901 MID-FLORIDA WAREHOUSE (AIPO) MASTER PLAN

Applicant's Request: Master Plan approval to construct a ±167,000 sq. ft. cross-dock warehouse/distribution facility on the west central part of the Airport Industrial Park of Orlando. The property is in the Boggy Creek neighborhood and is zoned I-G.

Staff Recommendation: Approval of the Master Plan, subject to conditions in this staff report.

SITE PLAN

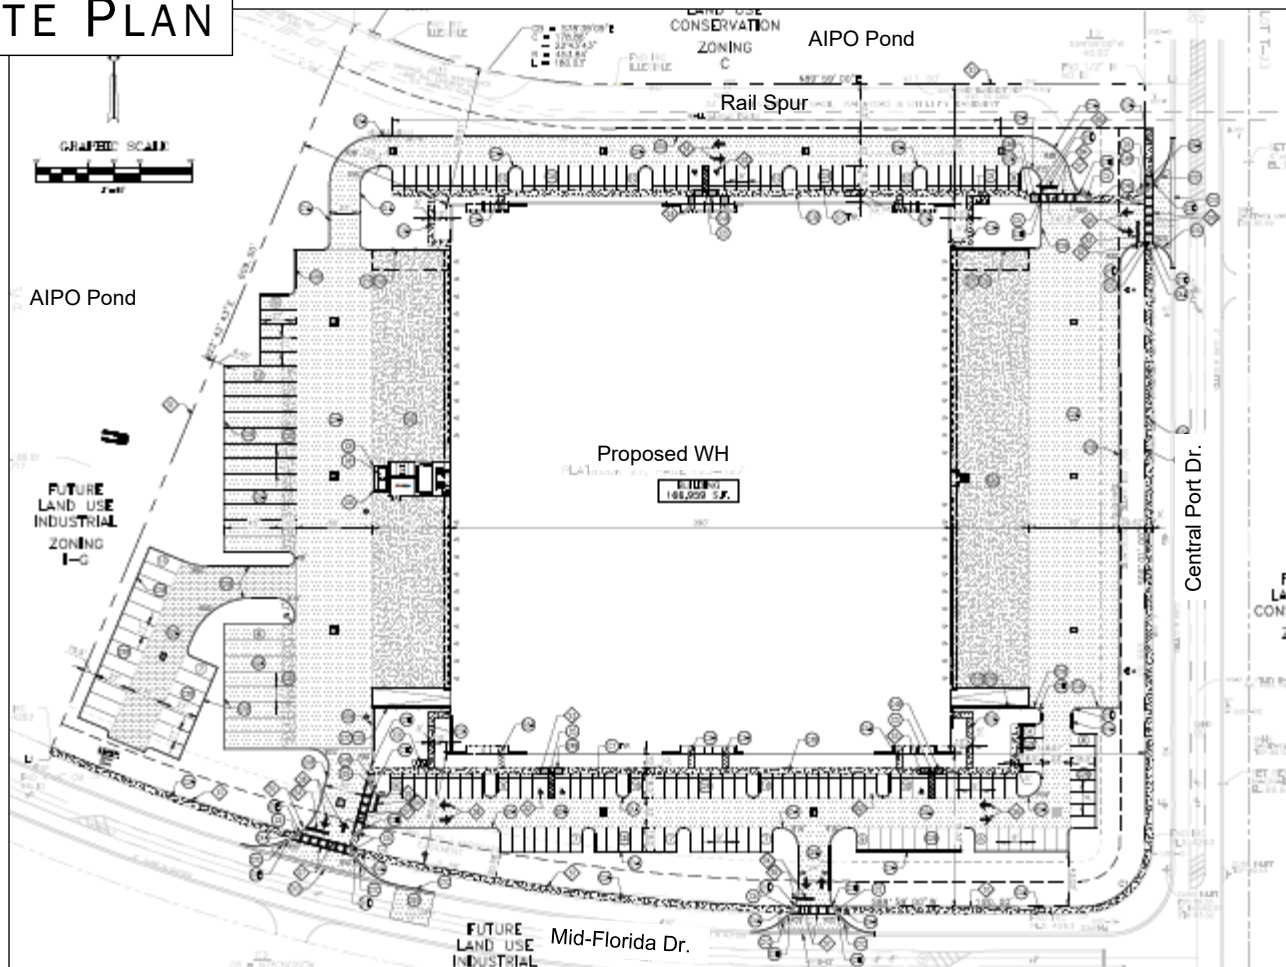
Solid Waste. A double dumpster solid waste receptacle is shown on the south side of the rear truck court, to be located in a walled corral with decorative walls and gates to match materials and finishes of the proposed warehouse. All dumpsters will need to allow the required minimum 50-ft. back-up distance for solid waste vehicles.

3. An Autoturn analysis must be provided (as specified) for the following vehicles:
 - A. Solid Waste Vehicle - to the proposed solid waste container, with a minimum 50-ft backup space required for the solid waste vehicle.

5. Parking lot and parking space dimensions must comply with the Orlando LDC and ESM.
6. The final site plan must show the location and size of the on-site double solid waste compactor(s) / dumpster(s) with concrete pads, and enclosures with doors. Dumpsters must be located to provide a minimum 50 ft of clear backup space and constructed per Orlando ESM requirements, or documentation must be provided from the City's Solid Waste Division indicating curb pick-up or other approved arrangement. Sidewalks

PROPOSED BUILDING ELEVATIONS

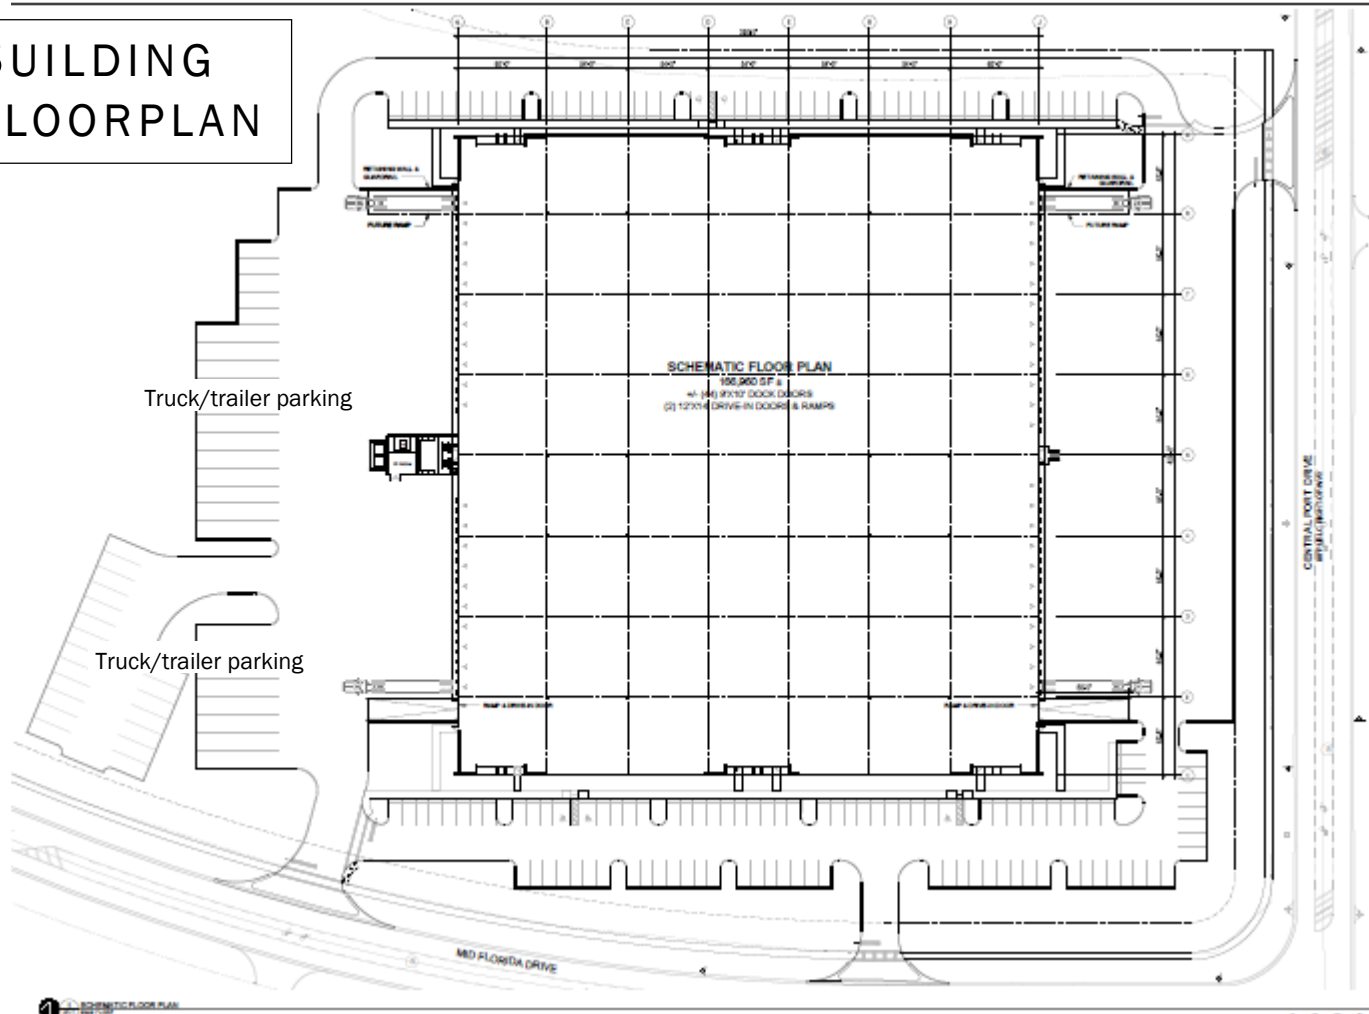
2. For industrial building facades, a base, middle, and top must be expressed, with materials, finishes, and details wrapped on all facade corners to a logical architectural endpoint. Stucco is not an acceptable base material.
3. Changes in parapet height must incorporate returns from the facade, to give the impression of architectural depth and mass.
4. Primary pedestrian entries must be clearly expressed and highlighted and recessed or framed by a sheltering element such as an awning, arcade, porch, portico, or canopy.
